REF: SPR-30-24  
DATE: July 11, 2024

| Request           | - | Major Site Plan Review for a Self-Storage Facility                            |
| Location          | - | 5055 Jackman Road   |

MAJOR SITE PLAN REVIEW  
TOLEDO CITY PLAN COMMISSION  
REF: SPR-30-24  
DATE: July 11, 2024  
TIME: 2:00 P.M.

# 25'x130' BUILDING ELEVATIONS

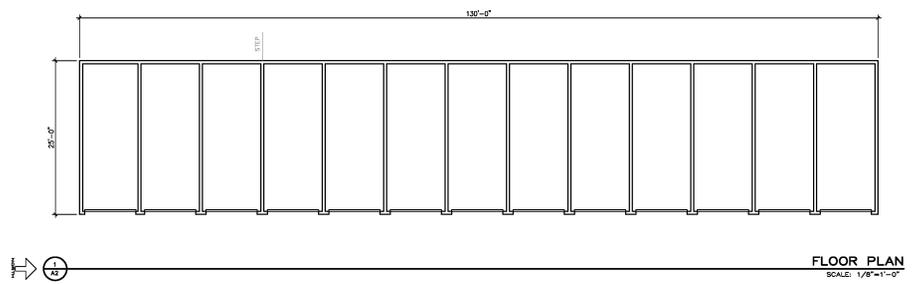
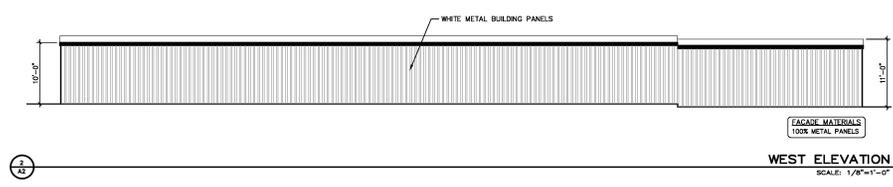
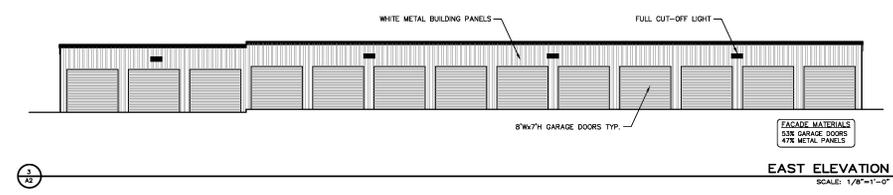
33. Windows shall occupy at least forty percent (40%) of the area between two and ten feet at grade from the base of the primary elevation facing the right-of-way. **Not acceptable as depicted. Windows comprise an average of thirty-seven percent (37%) of the area between two (2) and ten (10) feet on the primary elevation(s). Revised elevations shall be submitted showing windows occupying at least forty percent (40%) of the area between two (2) and ten (10) feet of elevations facing Jackman Road.**
